Notification Date: August 5, 2024
Effective Date: September 9, 2024

PRODUCT CHANGE NOTIFICATION

Default Password Change

Figure 1: Password on the Product Label

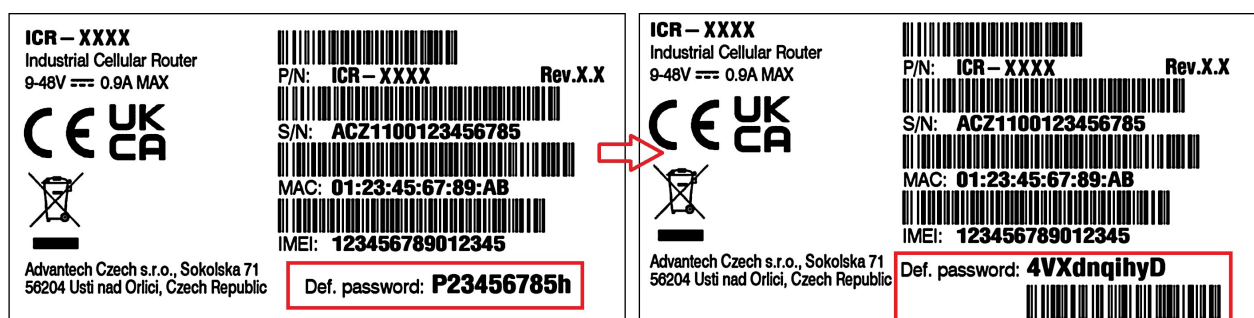
Detailed Description of the Change: The format of unique passwords for default user is being changed. Previously, the format was `Pxxxxxxxxh`, where the middle part was a number derived from the product serial number. The new password will have the same length but all characters will be generated randomly. Additionally, a new barcode containing the password will be printed on the product label. See the figure below for a comparison of the product label before and after the password change.
